PB2012-05-SM-CK-00	APPLICO PARTS BULLETIN
MODELS:	SUK91*, SA9066*, C9*
PARTS:	811650197 – ELECTRONIC CARD
ISSUE:	NEW TYPE CARD WILL NOT FIT ON OLD BRACKET

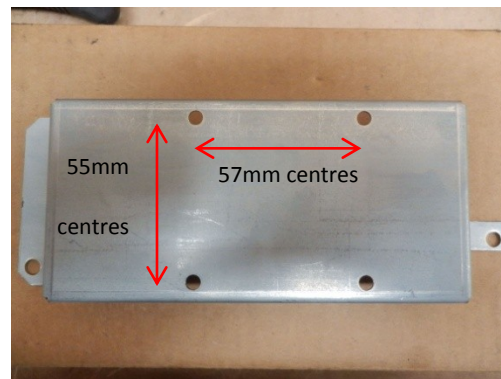
The electronic card has been updated and is now physically smaller than the original board (the part number has not changed). On models that were produced prior to 23-09-2004 the bracket mounting points for the card measure 57 x 55mm between centres. The new card mounting holes measure 53 x 42mm between centres.

New type card.

Old bracket.

The new card can be fitted onto the old board by inserting two of the 53mm centre standoffs into the 55mm centre holes then marking the position of the two remaining standoffs and drilling two 5mm holes to suit.
